<b>Technical Service Bulletin</b>	<b>GROUP</b>	<b>NUMBER</b>
	<b>RECALL</b>	<b>22-01-046G</b>
	<b>DATE</b>	<b>MODEL(S)</b>
	<b>MAY, 2022</b>	<b>G70 (IK)</b>
<b>SUBJECT:</b> TRUNK LATCH BASE REPLACEMENT (RECALL 010G)

**Description:** On certain G70 (IK) vehicles, the trunk latch pawl can thermally contract when exposed to high ambient temperatures. An attempt to release the pawl and open the trunk lid in this condition could result in damage to the pawl, preventing opening of the trunk lid through actuation of the emergency trunk release and presenting risk of injury to an occupant locked in the trunk. This bulletin describes the procedure to inspect and if necessary, replace the trunk latch base with improved parts.

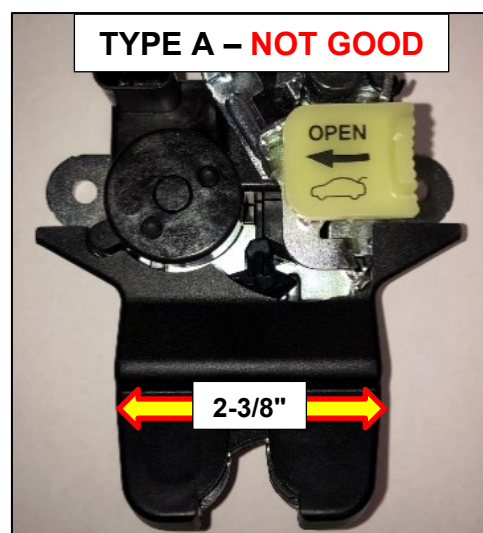
If the trunk latch is approximately 2-3/8" (58 mm) wide at the base, it is a type A latch and the trunk latch base needs to be replaced. Proceed to the next section for the repair procedures.

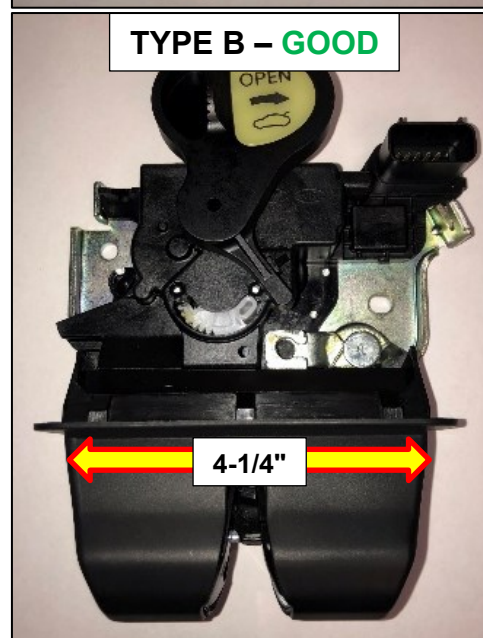
If the trunk latch is approximately 4-1/4" (101 mm) wide at the base, it is a type B latch and does not need to be replaced. No further action is required and the inspection is complete.

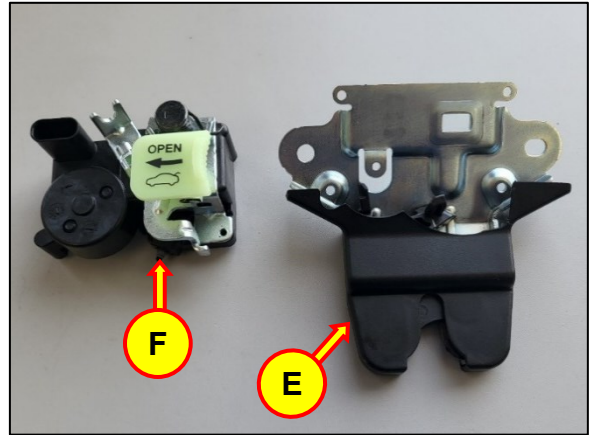
7. Replace the trunk lid latch base (E) and reuse the actuator (F).

5.1 – 8.0 ft-lb (6.9 – 10.8 Nm)
